October 21, 2011

Memorandum

Subject: Trip Report to Drewry's Bluff Unit of Richmond National Battlefield Park
September 13, 2011

Schematic drawing of a French drain system

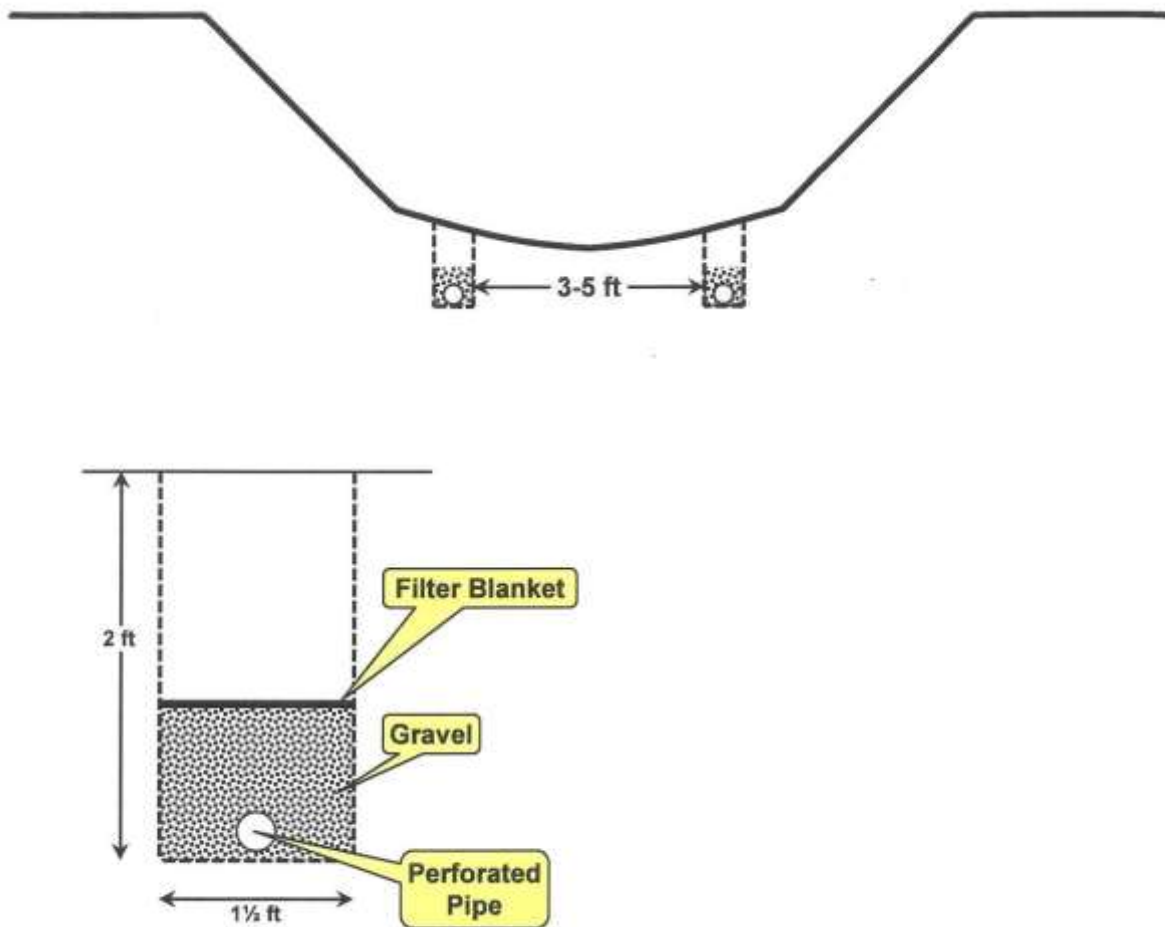
Installation of a French Drain system may provide an alternative to previous proposals for bluff stabilization. A French drain system could be installed in stages; constructing first at a trial site away from the main fort area. If the trial site showed that it was effective at intercepting infiltration, additional drains could be installed at other areas closer to the fort. The drain system would start with excavation of shallow trenches in the swale areas. The trenches would be backfilled with gravel and drain pipes to intercept water infiltrating into the ground and pipe the water away from the bluff, possibly discharging the water to the unnamed creek on the west side of the fort.

The design shown in this schematic is only to present the concept for discussion and consideration. If park management desires to pursue this alternative, advice should be sought from engineers or other professionals with expertise in design and construction of drainage systems.
